Flight Procedures Cover Page	Task Action: FLIGHT CHECK	Task Type: IAP	Estimated Chart Date: 06/12/2025	APWS Task ID: E1D7987AE57A4C29817C411170259948	APWS Project ID: 5A4694DC546C4DA3B95E909E46CAFE5
Procedure: ILS OR LOC RWY 17 AMDT 3A		Enroute: NO	Specialist: Slane, Cory		Agreement Number:
Airport ID: KMTJ			Airport City: MONTROSE		State: CO
Facility ID: MTJ	Facility Type: ILS	Flight Inspection Remark Type: New FC Slot			
<p>Procedure Comments:</p> <p>ACTIVE AIRNAV DATA USED.</p> <p>SEGMENT ALTITUDE RAISES. IF CROSSING ALTITUDE RAISED. CLEARS NOTAM FDC 4/9190.</p> <p>NEW APPROVAL LETTER CREATED FOR THE USE OF PPV ON ILS FINAL. NEW WAIVER CREATED TO NOT DEVELOP A CAPTURE FIX.</p> <p>POC: JOHN BORDY, AJV-A33, 405-954-0980</p> <p>04/21/2025: THIS IS AN UPDATED COPY OF THE FORM DEVELOPED ON 12/20/2024. 8260-2: 1. FIX GRAND JUNCTION VOR/DME: ADDED SIGNATURES.</p> <p>05/06/2025: THIS IS A CORRECTED COPY OF THE FORM APPROVED ON 04/03/2025. TERMINAL ROUTES: DELETED DISTANCE ON THE PAGRE TO BRUUK ARC.</p>

Subject: Approval Request: Montrose Rgnl (KMTJ), Montrose, CO

ILS OR LOC RWY 17, Montrose Rgnl (KMTJ)

ILS or LOC RWY 17

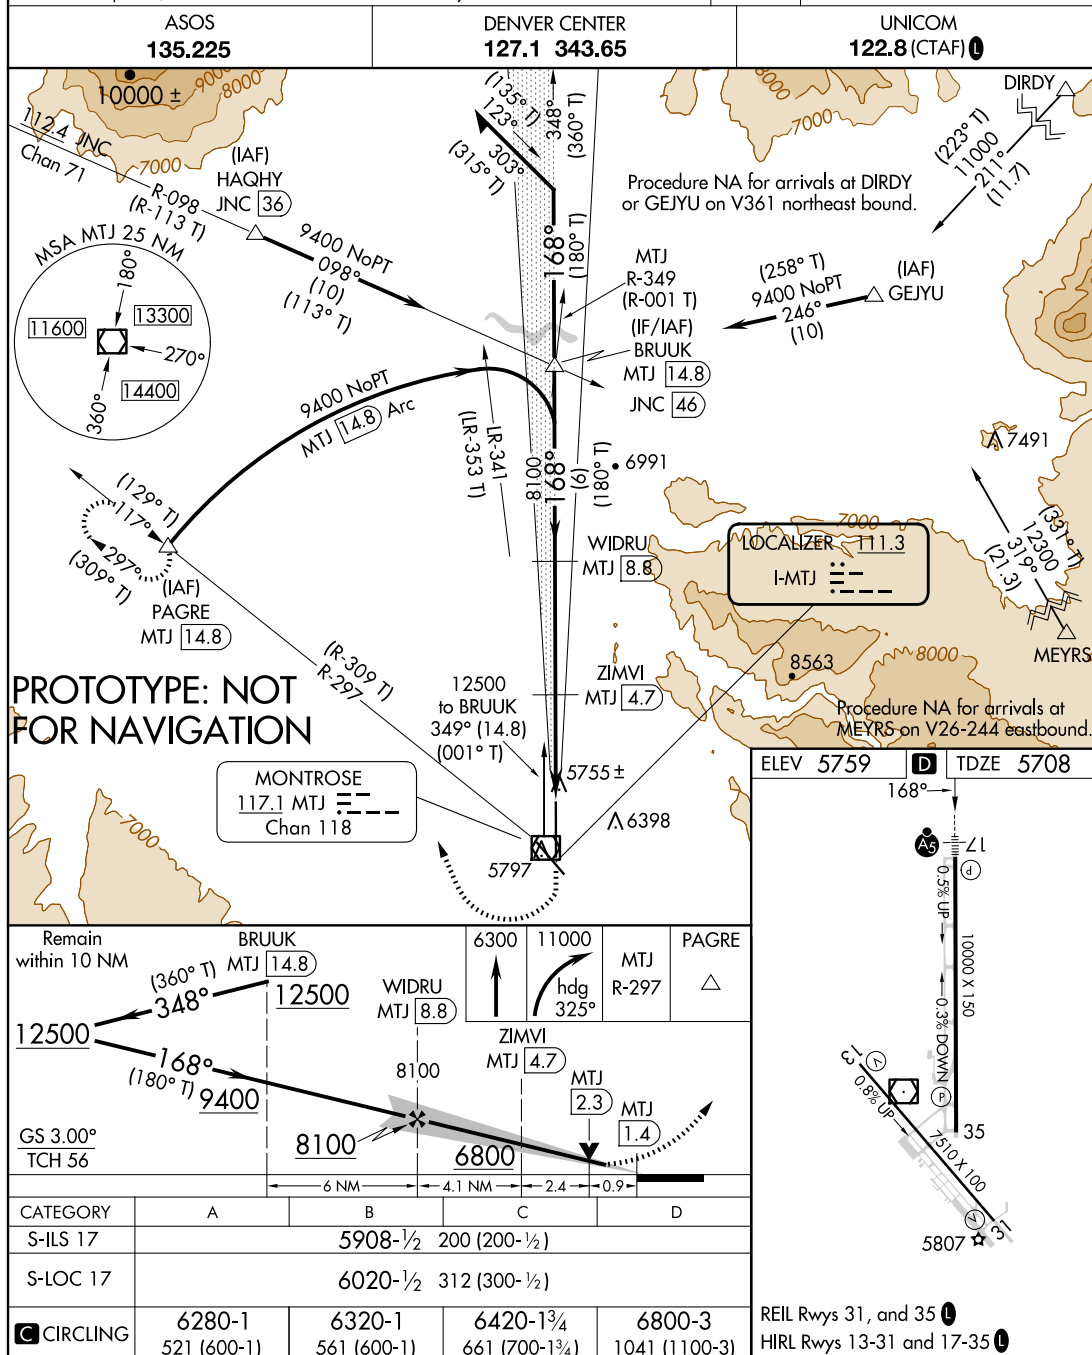
Request waiver to not develop a capture fix. Applicable Standard is FAAO 8260.58C, Appendix C.para 2a(1): Establish a capture fix. Construct a TF leg aligned with the FAC that is common to all intermediate segments. The start fix of the leg is designated the capture fix. Alternatively where operationally necessary, the capture fix may be placed on or at the start of an RF leg. The preliminary location of the capture fix may be less than 2 NM but no closer than 1 NM prior to the PFAF.

The intent of a capture fix is to ensure aircraft can capture the glide slope when turning on to the final course prior to the PFAF. Developing a capture fix at this stage would require a new CATEX review, which would significantly delay the planned publication date of June 12, 2025.

The primary objective of this project is to clear a NOTAM that has been active from March 20 2024 to end on October 30th 2024. this NOTAM has increased the circling minima. The reason of this temporary waiver is to postpone the development of a capture fix until March 19, 2026. By this date, a revised procedure will be published, (amendment 4) to incorporate the capture fix, effectively revoking the waiver.

The intermediate segment for this procedure is 6 NM and aligned with the final approach course. There are no turns between the intermediate fix (IF) and the final approach fix (FAF). The turn at the IF has a DTA that is no closer than 2NM prior to the PFAF. The descent gradient between BRUUK (IF) and WIRDU (FAF) is 267ft/NM .The altitudes provided at the IF and FAF allow for continuous descent through the intermediate and final segments.
